Work Order ID 133610

Item Name: Crosstube Turning Detail

DRAWING NO. D407-667-145	TITLE CROSSTUBE ASS'Y (407 HIGH FWD)	REV. C	DART AEROSPACE LTD ENGINEERING ORDER		D.E.O. NO. D407-667-145-C-1	SHEET NO. SHEET 1 OF 1	SCALE NTS
DRAWN 97	CHECKED ASS	MFG. APPR. 188	APPROVED WD		DE APPR. 11		
DATE 11.07.15	DATE 11.07.22	DATE 11.07.22	DATE 11/07/22		DATE 11.07.21

DRAWING NO. D407-667-145	TITLE CROSSTUBE ASS'Y (407 HIGH FWD)	REV. C	DART AEROSPACE LTD ENGINEERING ORDER	D.E.O. NO. D407-667-145-C-2	SHEET NO. SHEET 1 OF 1
DRAWN AJS	CHECKED	MFG. APPR. <i>E</i>	APPROVED <i>140</i>	DE APPR. <i>140</i>	
DATE 12.08.02	DATE 12.08.02	DATE 12.08.02	DATE 12.08.02	DATE 12.08.02	DATE 12.08

DETAIL P
BONDING STRAP INSTALLATION 2 P

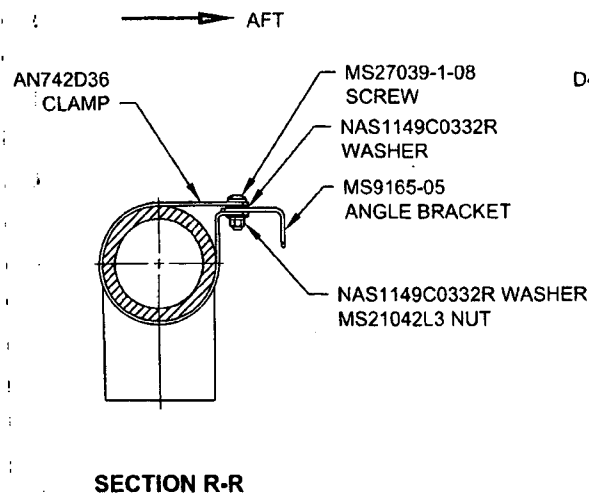
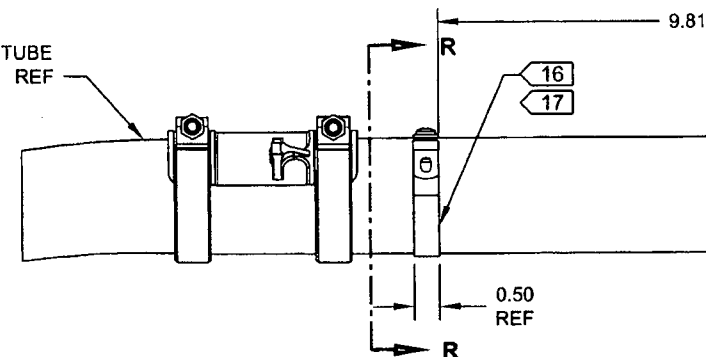
ADD ELECTRICAL GROUNDING STRAP

ITEM	QTY -145	PART NUMBER	DESCRIPTION
1	X	D407-667-145	CROSSTUBE ASSEMBLY (407 HIGH FWD)
10	2	AN742D36	CLAMP
11	2	MS9165-05	ANGLE BRACKET
12	2	MS21042L3	NUT (OR MS21042-3)
13	2	MS27039-1-08	SCREW
14	4	NAS1149C0332R	WASHER (OR AN960C10L)

- 16) MASK AREA UNDER CLAMP PRIOR TO PAINTING
- 17) SEAL EDGES WHERE AN742D36 CLAMP MEETS WITH THE CROSSTUBE USING SIKAFLEX-241/-291 OR MIL-S-8802 CLASS B2 OR PROSEAL 890 SEALANT
- 18) PERFORM RESISTANCE CHECK TO ENSURE MAX RESISTANCE IS 10 MILLIOHMS
